RE: **PETITION NO. 1344** - The Connecticut Light and Power Company d/b/a Eversource Energy declaratory ruling, pursuant to Connecticut General Statutes §4-176 and §16-50k, for the proposed replacement of approximately 11 miles of its existing No. 1342 115-kilovolt (kV) electric transmission line structures within existing Eversource electric transmission line right of way between the existing Green Hill Substation located at 775 Green Hill Road in Madison and the existing Bokum Substation located at 49 Bokum Road in Old Saybrook, Connecticut, traversing Madison, Killingworth, Clinton, Westbrook, Essex and Old Saybrook, and related electric transmission line structure improvements.

The Connecticut Siting Council (Council) is in receipt of your correspondence dated May 6, 2019 regarding a minor project change to the above-referenced project that was approved by the Council on July 19, 2018. The minor project change consists of the replacement of existing transmission line structure #4925 after an in-field assessment determined that this three-pole wood structure is in an advanced state of deterioration. A new three-pole weathering steel structure of similar height will be installed

NO. DATE		REVISIONS	BY	APP.
1	5/1/19	Added Proposed Str. 4925	NC	BP
NO. DATE		REVISIONS	BY	APP.
EVERSOURCE ENERGY				
Transmission Line Maintenance				
Green Hill to Bokum Upgrade Project				
		Old Saybrook, CT		
		Map Sheet 19 of 19		
		May, 2019

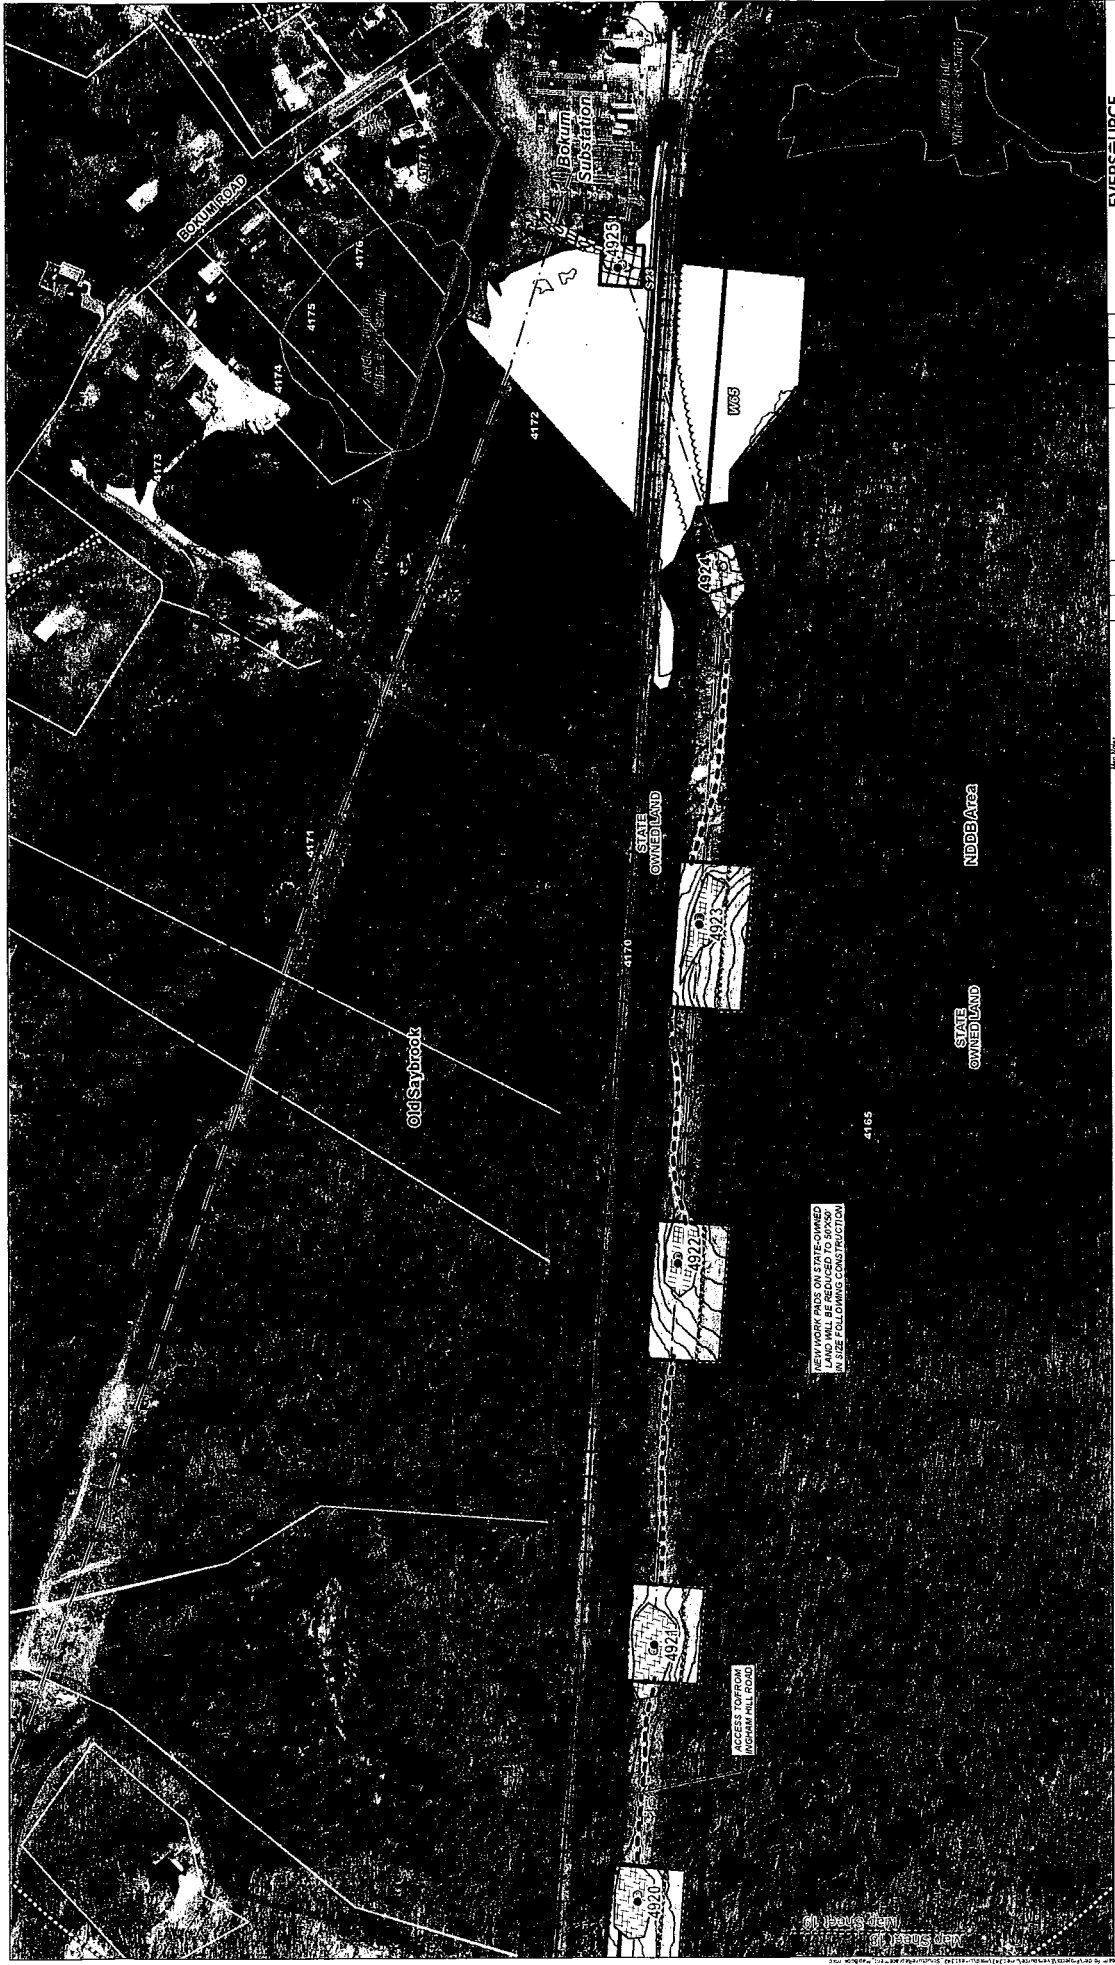
On October 27, 2017, the Connecticut Siting Council (Council) issued a ruling that the subject Project would not have an adverse environmental effect and would not require a Certificate of Environmental Compatibility and Public Need. Not included in the scope of work proposed in Petition No. 1344, was the replacement of existing structure 4925, located on Eversource property to the west of Bokum Substation. Since the time of the Council's ruling, Eversource re-evaluated the integrity of structure 4925 and determined that it requires replacement.

Structure 4925 is a three-pole wooden structure would be replaced similar in kind with a three-pole weathering steel structure. The new structure will be placed approximately six feet north from its existing location. The height of the existing structure is 76 feet above ground level and the new structure would be similar in height. (See attached revised mapsheet 19).

Approximately 150 square feet of permanent wetland impacts within a previously disturbed area is required due to the minor location structure shift of this three pole structure. Eversource provided notice to the Connecticut Department of Energy and Environmental Protection and the U.S. Army Corps of Engineers of this modification.

Pursuant to Condition No. 1 of the Council's July 19, 2018 Declaratory Ruling, your request for the above minor project change, as detailed in your May 6, 2019 correspondence, is hereby approved. This approval applies only to the minor project changes described in your May 6, 2019 correspondence. Any significant changes to the project require advance Council notification and approval.
